Mixed-Use Development
2 Mark Street & 1-3 Marsden Street, Lidcombe NSW 2141

Development Application

to approved DA 2022 / 0253

DA - B	DRAWINGS UPDATED IN RESPONSE TO DEAP MEETING & COUNCIL RFI (June 2025)	19/08/2025	YT	AHM
DA - A	ISSUED FOR DEVELOPMENT APPLICATION	17/02/2025	YT	AHM
DA - P.3	ISSUED FOR DEAP MEETING	18/06/2024	YT	AHM
ISSUE	AMENDMENT	DATE	DRAWN	CHECKED
Drawing is NOT VALID or issued for use, unless checked.

SHEET TITLE:
Level 8 Plan (Rooftop COS) - BOARDING
DESIGNED: AHM DRAWN: YT COMMENCED: April 2024
SCALE: 1:100@A1 1:200@A3 or as noted
PRINT: A1 SHEET A3 SHEET
PLOT: Wednesday, 13 August 2025 4:26 PM
L.G.A: Cumberland Council

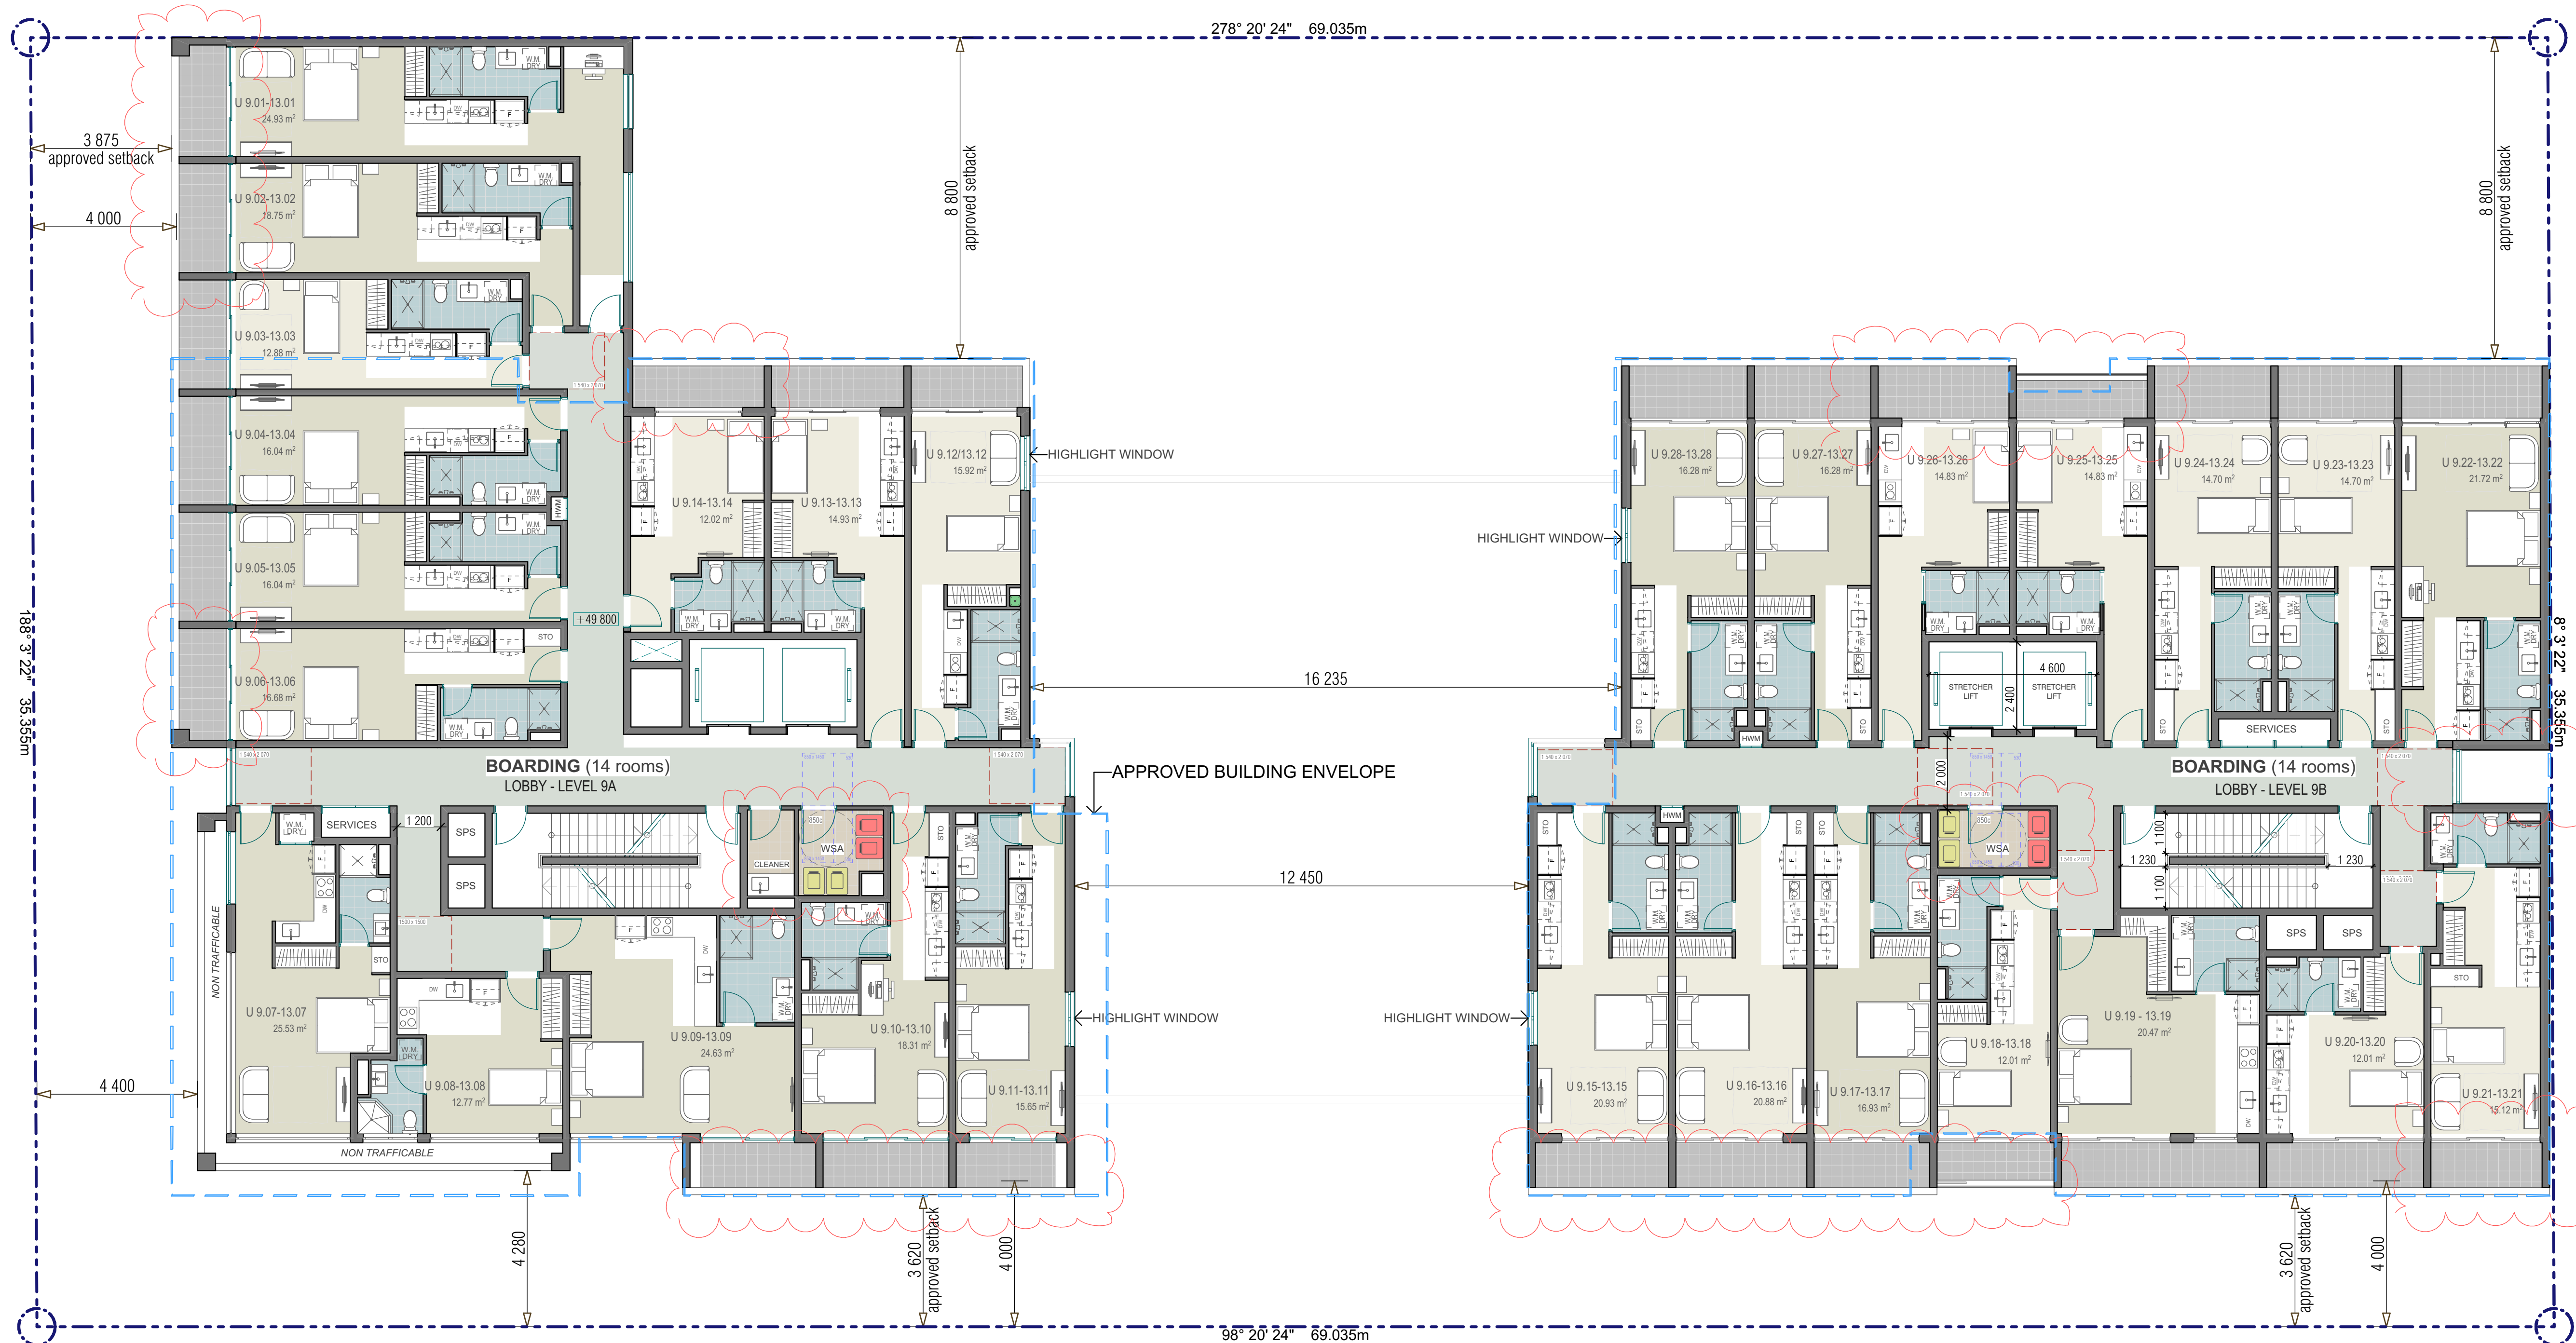
- Temporary bin cupboards relocated to minimise odour impact to residential entries
- Natural light into hallway provided to eastern side of building, adding passive surveillance over nearby park
- Rooftop terrace provided on level 8 (only)
- Balcony added to the clouded units to improve amenity

SHEET TITLE:
Level 9-13 Plans (Typ.) - BOARDING
DESIGNED: AHM DRAWN: Y T COMMENCED: April 2024
SCALE: 1:100@A1 A1 SHEET 1:200@A3 A3 SHEET or as noted
PLOT: Wednesday, 13 August 2025 4:27 PM
L.G.A: Cumberland Council

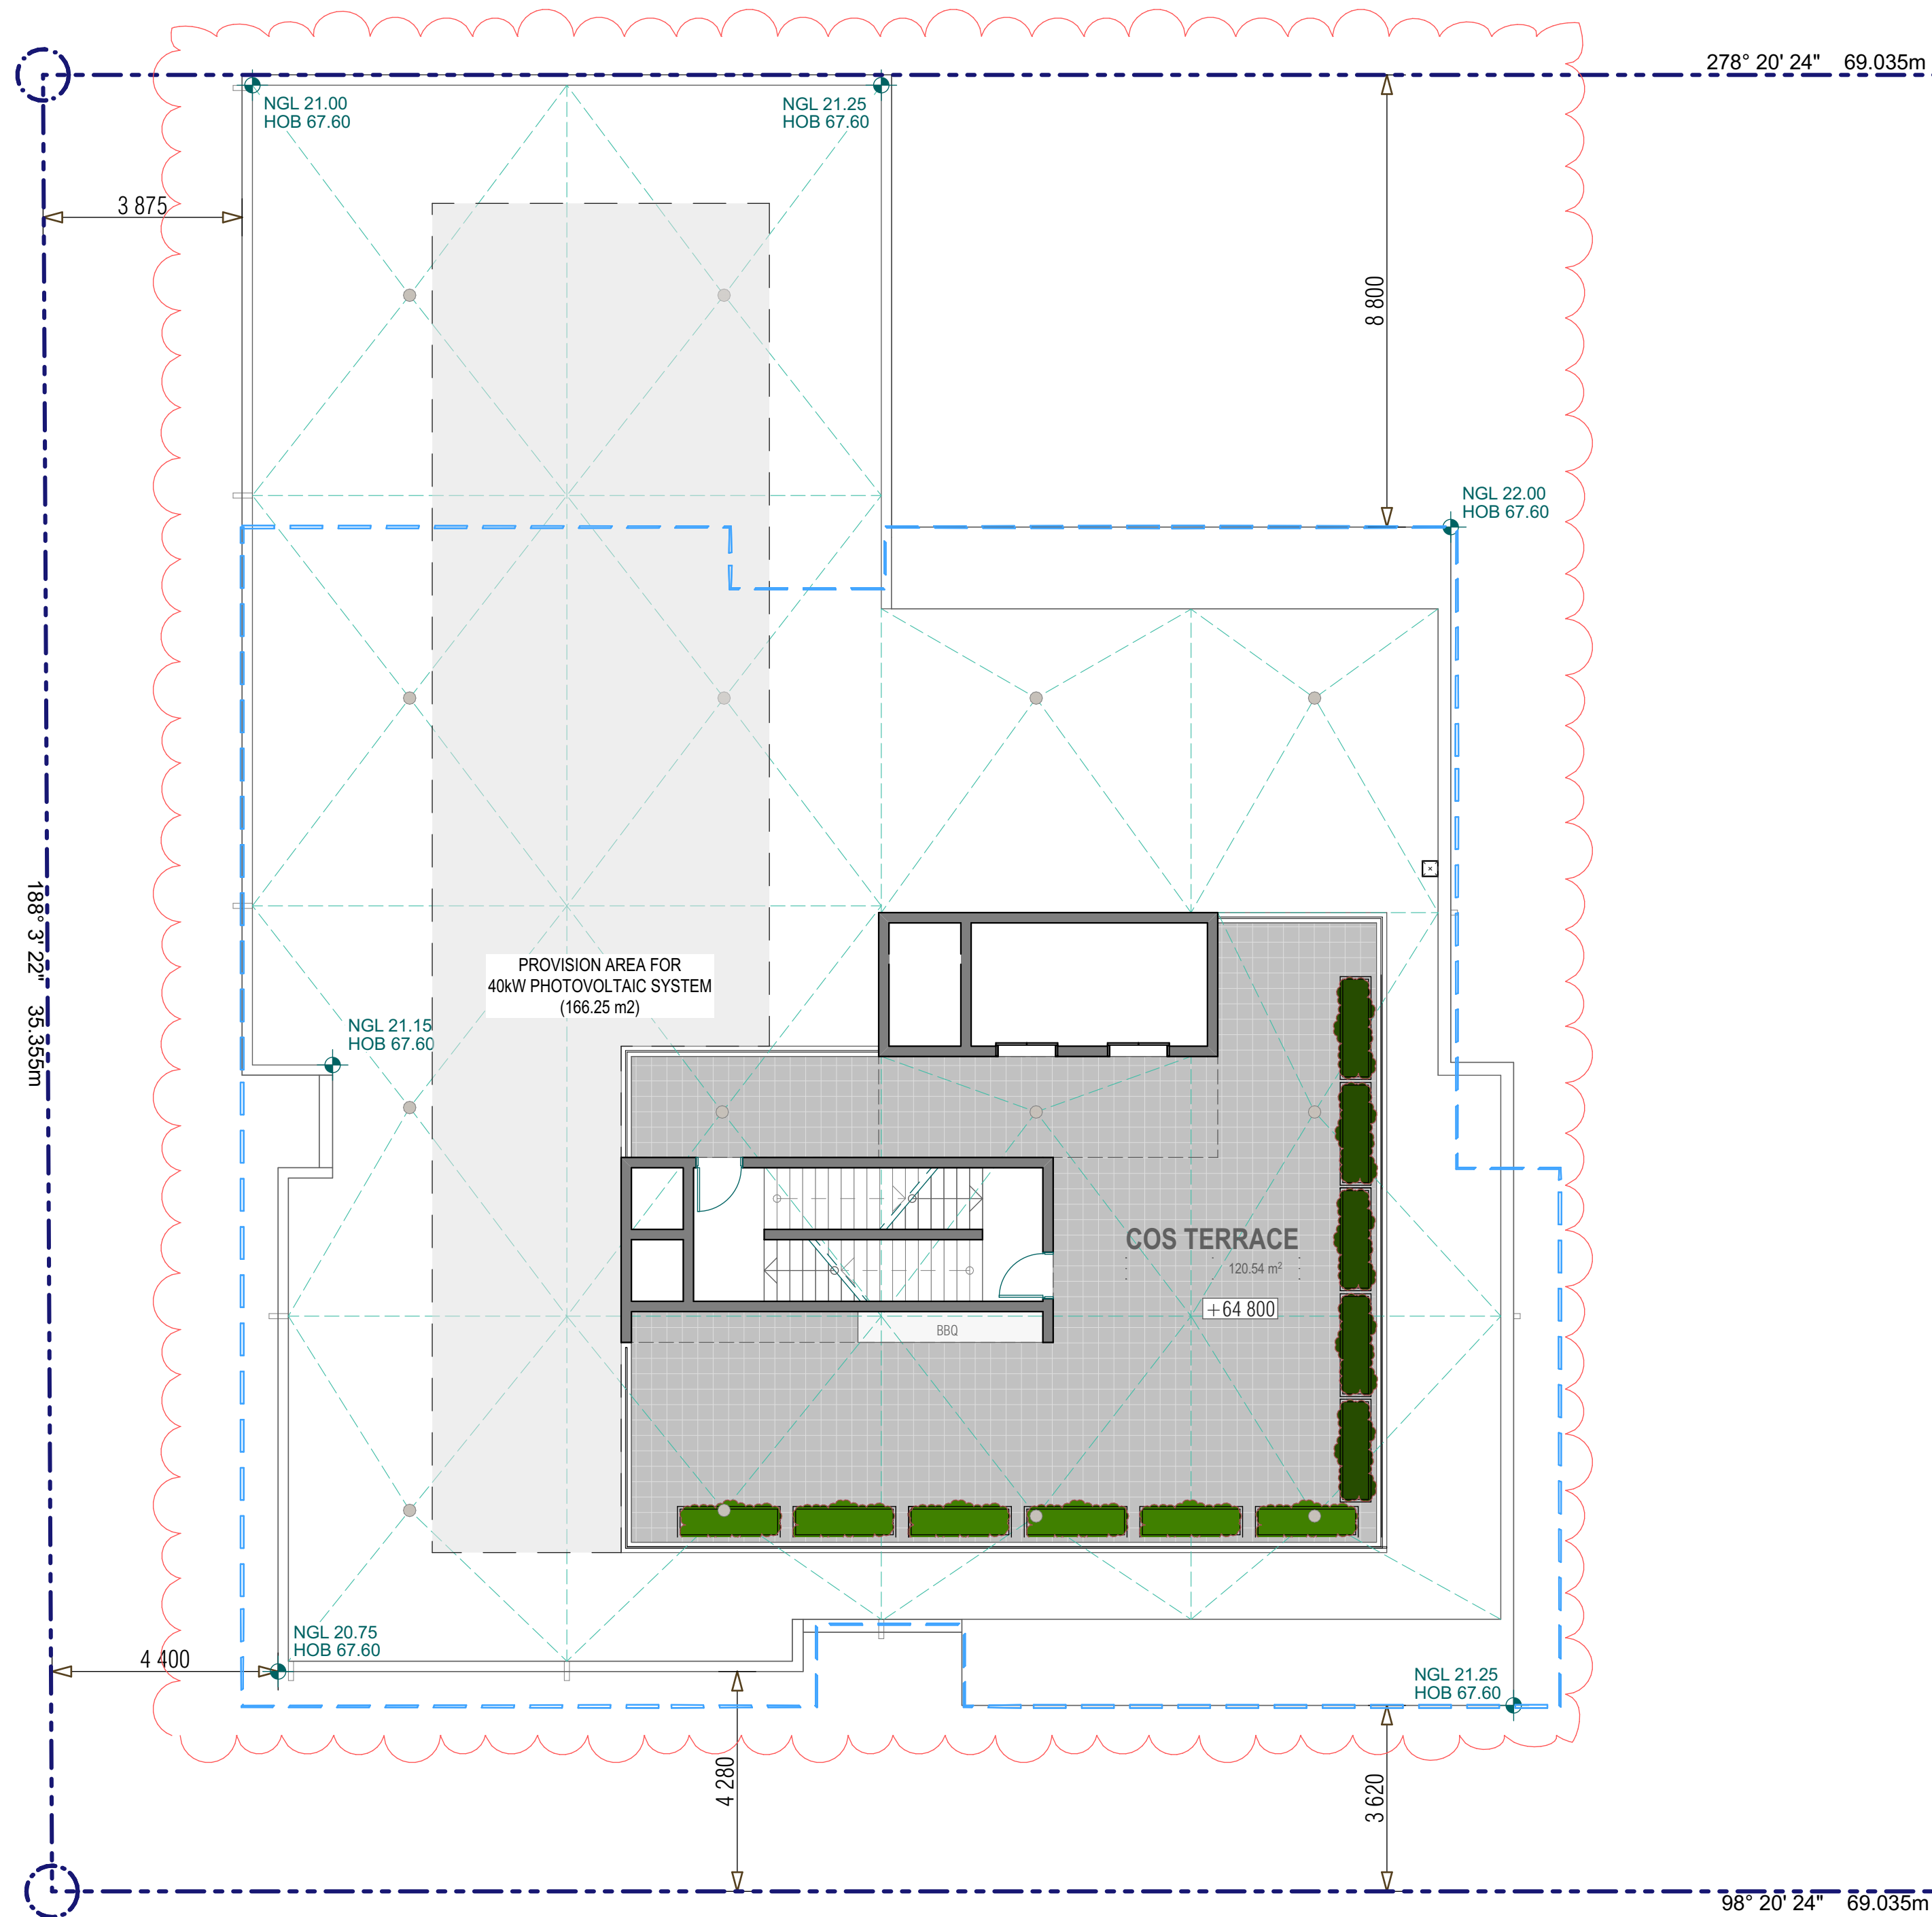
- Temporary bin cupboards relocated to minimise odour impact to residential entries
- Natural light into hallway provided to eastern side of building, adding passive surveillance over nearby park
- Balcony added to the clouded units to improve amenity

SHEET TITLE:
Level 14 Plan + Roof Plan - BOARDING
DESIGNED: AHM DRAWN: Y T COMMENCED: April 2024 SCALE: 1:100@A1 1:200@A3 or as noted PRINT: A1 SHEET A3 SHEET
L.G.A: Cumberland Council Monday, 18 August 2025 1:47 pm

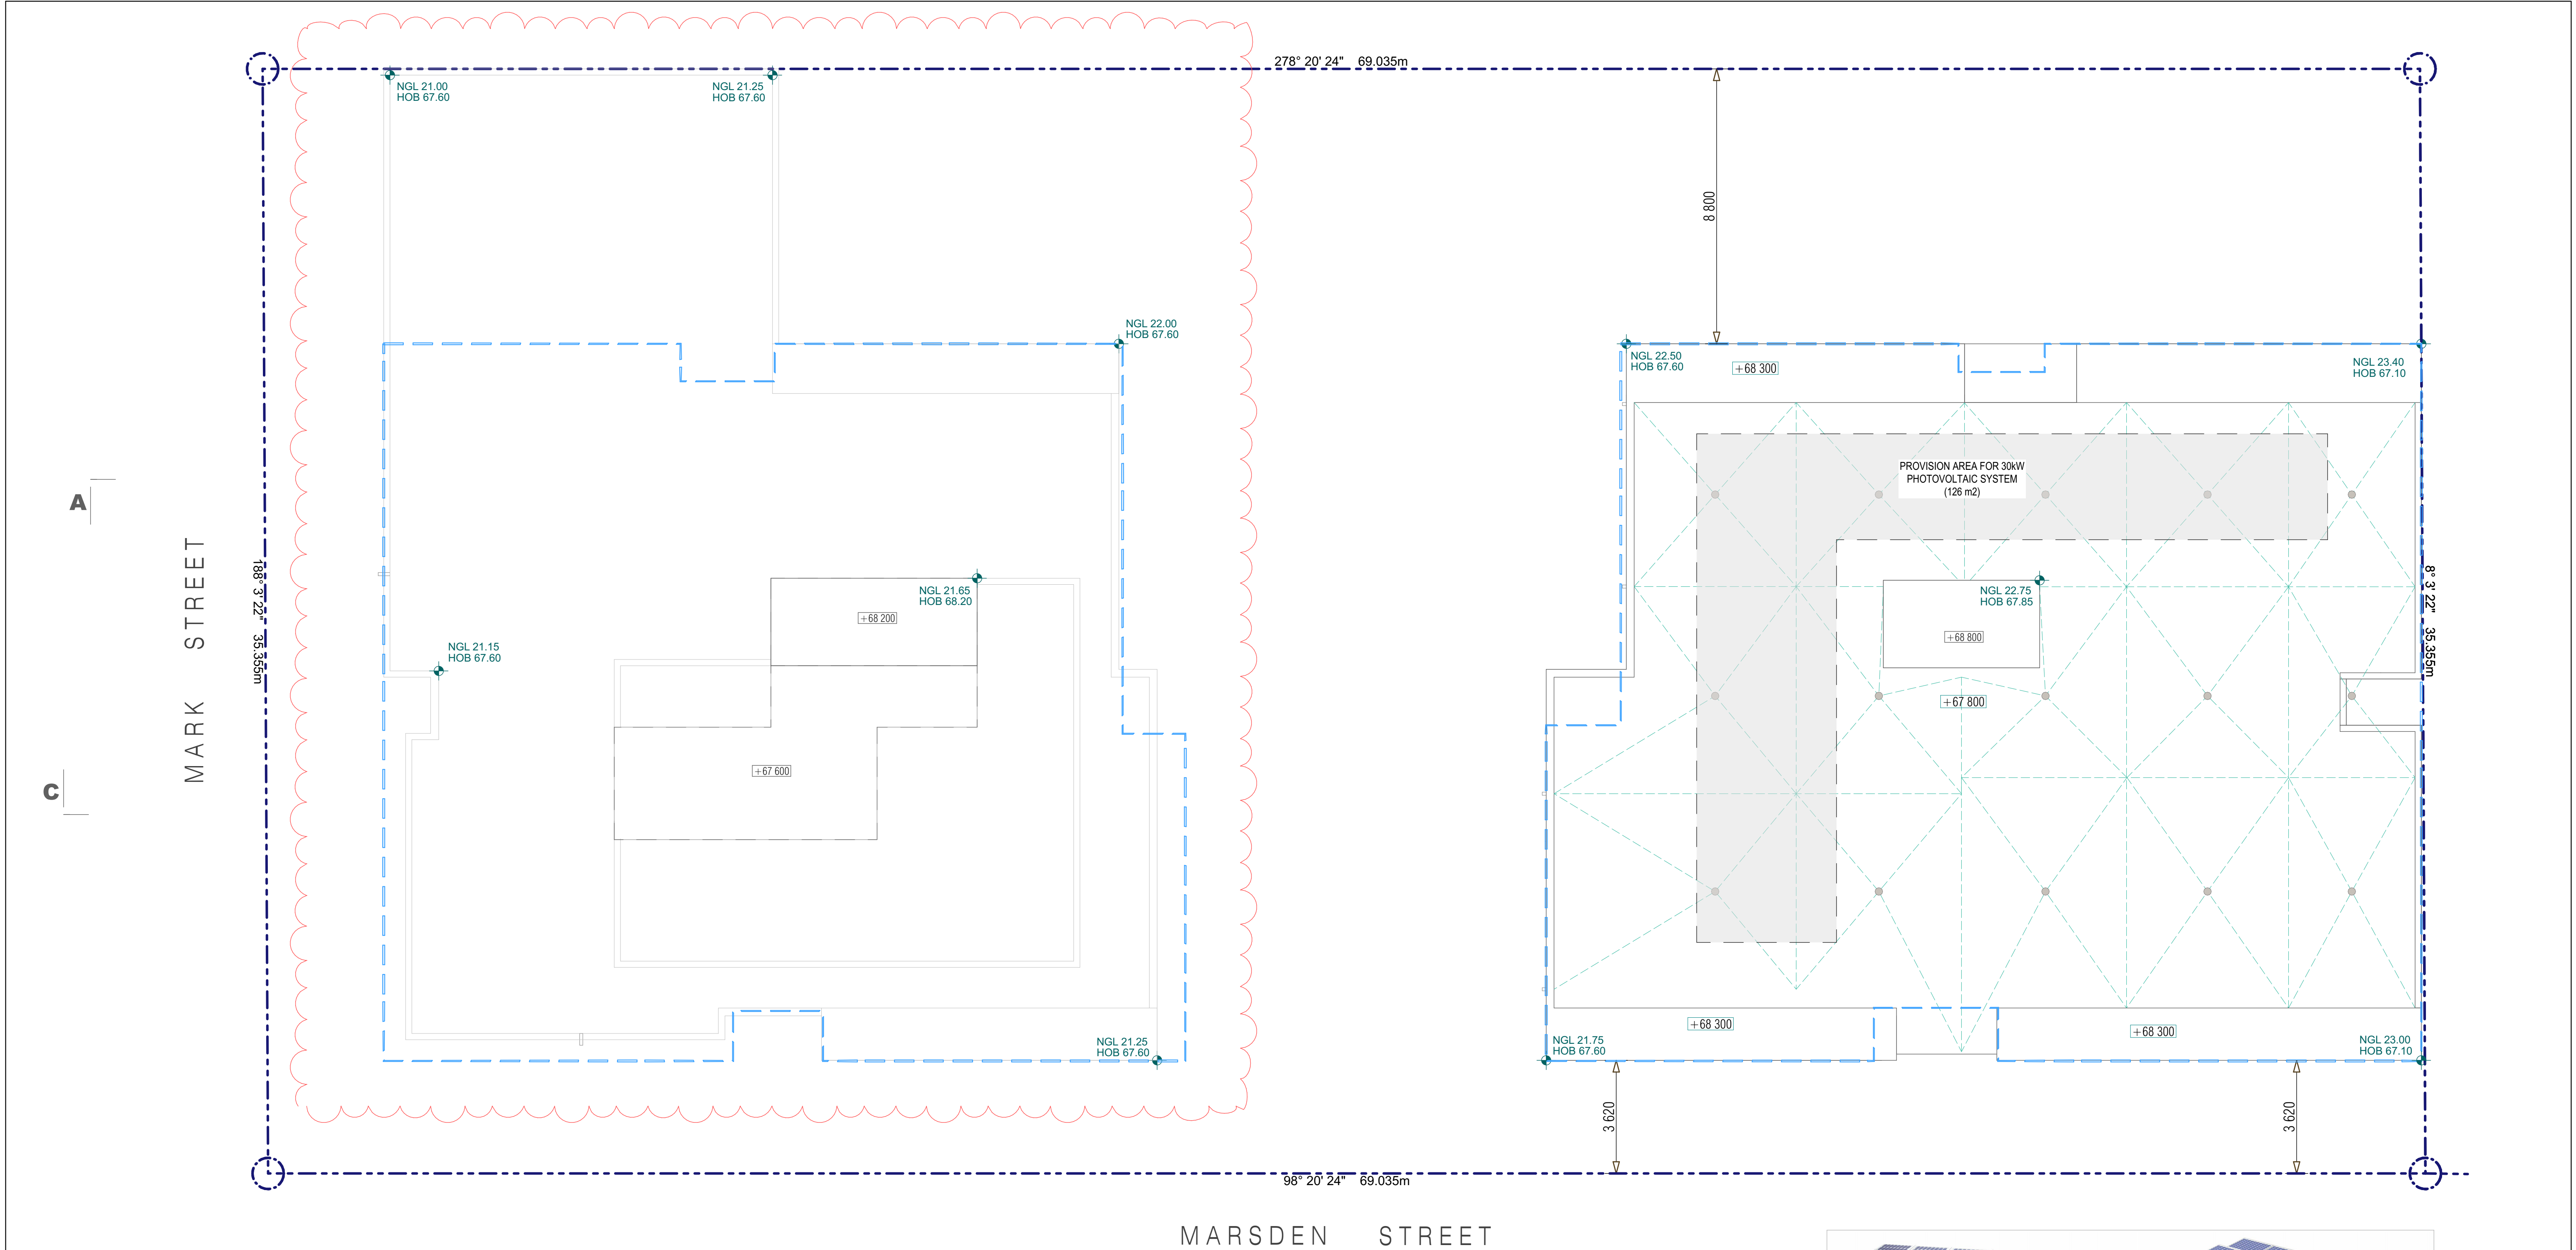
- Residential component previously on level 14 at western tower now deleted
- Temporary bin cupboards relocated to minimise odour impact to residential entries
- Natural light into hallway provided to eastern side of building, adding passive surveillance over nearby park
- Balcony added to the clouded units to improve amenity
